SERVICE BULLETIN

Service Bulletin No.: DA20-32-06 Rev 0

Title: NLG Wheel and Fork Installation Improvements

Figure 1 - NLG Fork Assembly Installation

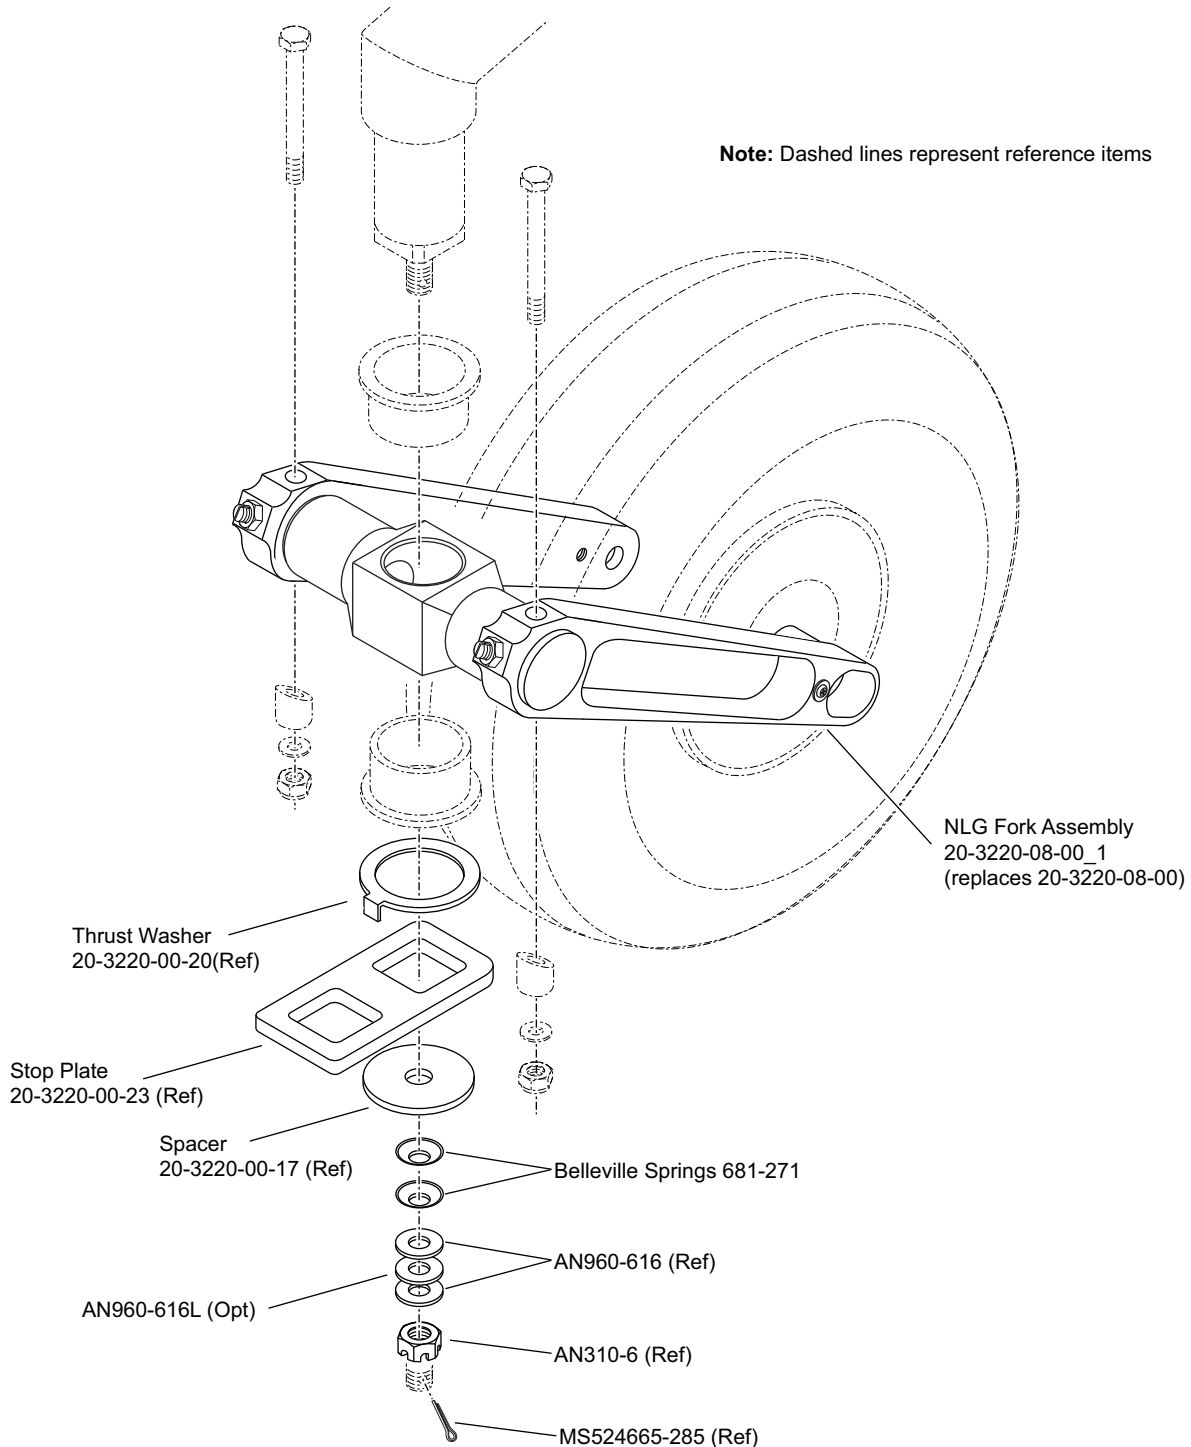
- 10.1 Either jack the aircraft in accordance with DA20-A1 AMM Chapter 07-10-00.
- 10.2 Remove the wheel in accordance with AMM Chapter 32-40-00
- 10.3 Remove NLG fork (A new fork assembly is available see SIL20A1-008) .
- 10.4 Inspect all parts for condition checking for cracks, corrosion and wear. New hardware should be used where necessary (For the fork assembly please review SIL20A1-008).
- 10.5 Apply CRC Corrosion Shell to the stud. Do not contaminate the tire or fiberglass.
- 10.6 Lubricate the axle in accordance with AMM Chapter 12-20-00.
- 10.7 Re install the fork using the new Belleville springs with the rest of the parts listed in figure 1. Be sure that both springs are installed with the open side facing up as per figure 1.

Figure 2 - NLG Wheel Installation with Shims

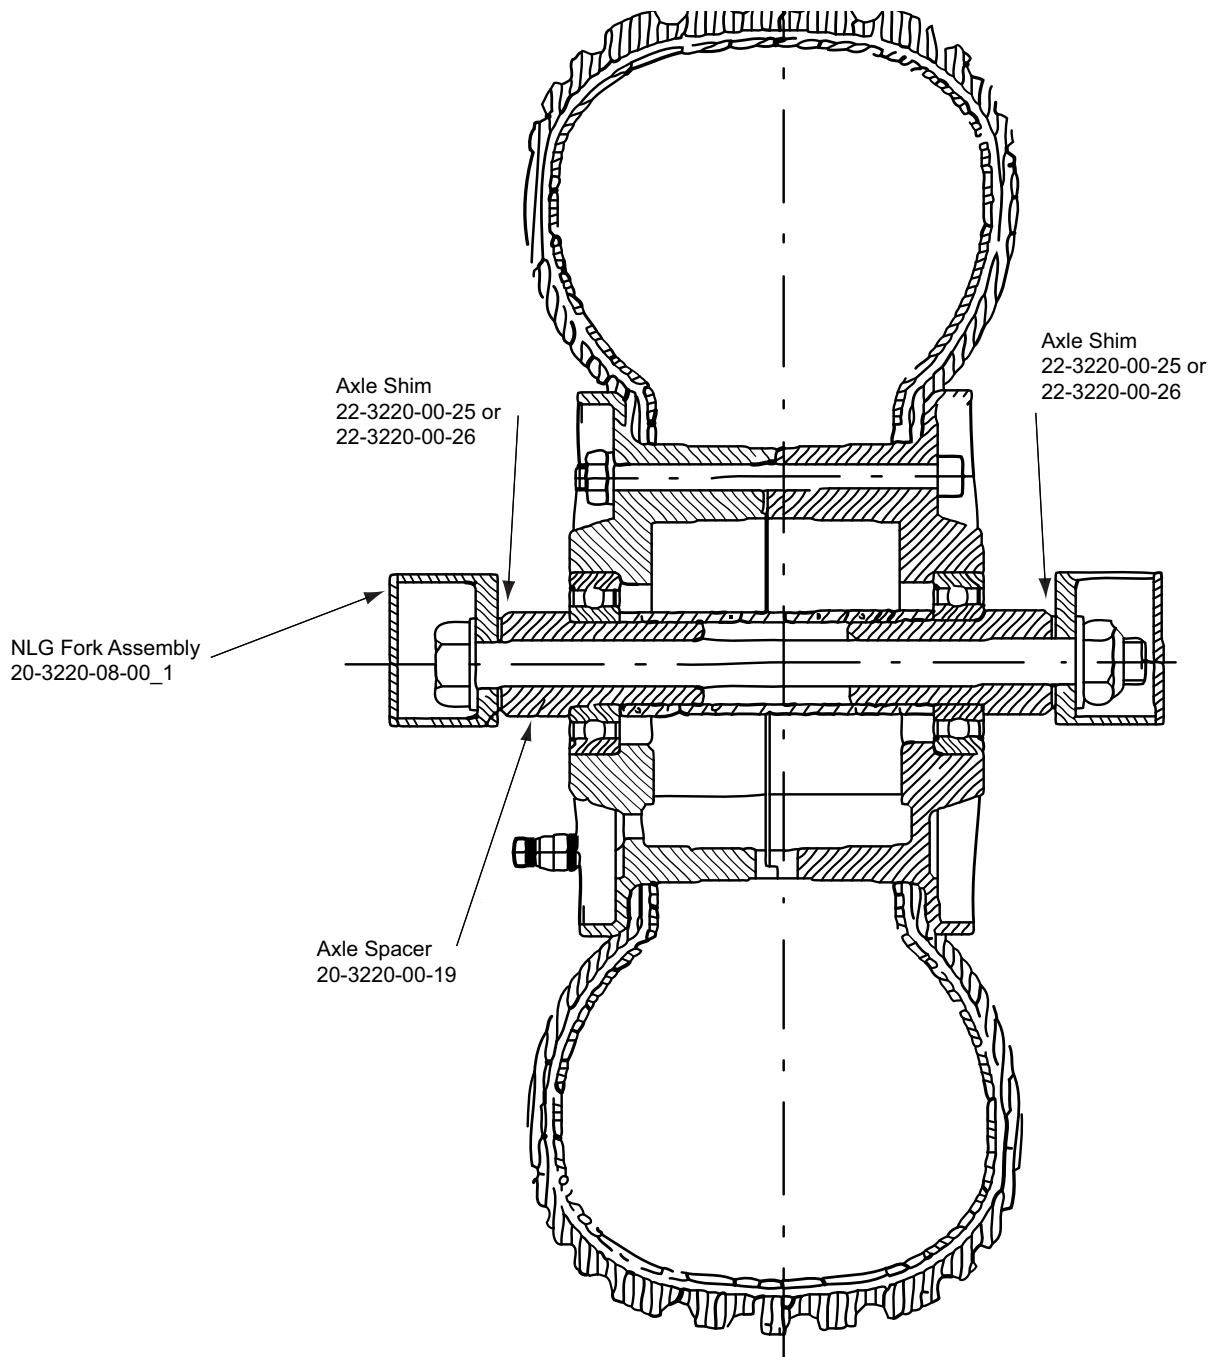
Note: The AN960-616L steel washer should be used if it is not possible to install the cotter pin correctly when adjusting the friction force.
- 10.8 Re install the wheel and use the shims to eliminate the gap between the axle spacer (20-3220-00-19) and the fork. Use a maximum of two shims and divide the shim installation evenly from side to side. Maximum difference between sides is 0.010". See figure 2.
- 10.9 Carry out friction adjustment as per AMM Chapter 32-20-00. Use the AN960-616L washer as noted above if required to properly install the fork and obtain the proper friction.
- 10.10 Make a log book entry that this Service Bulletin has been incorporated.
